From: **Joe Rast** jrast@ruby-collins.com  
Subject: HDD Alignment Change  
Date: January 3, 2021 at 6:52 PM  
To: **Matthew Minor** mattminor@gswsa.com

**DESIGN DATA**  
WACCAMAW RIVER HDD

See attached revised HDD design from Laney.

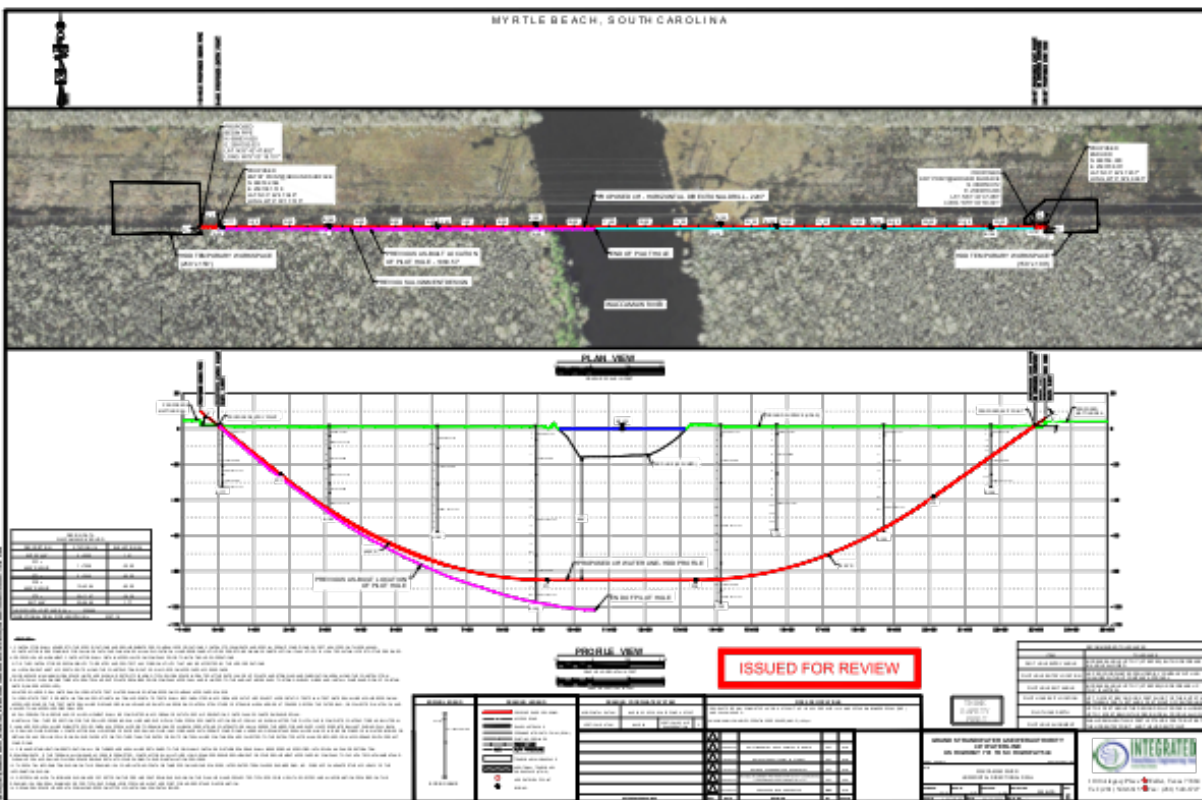
As you know, Laney has encountered some difficult ground conditions while performing the pilot hole for the HDD. They said the hole alignment has deviated as a result and is no longer in spec. They believe the best course of action is to pull out, shift over 5 feet (toward the powerline), and start a new hole.
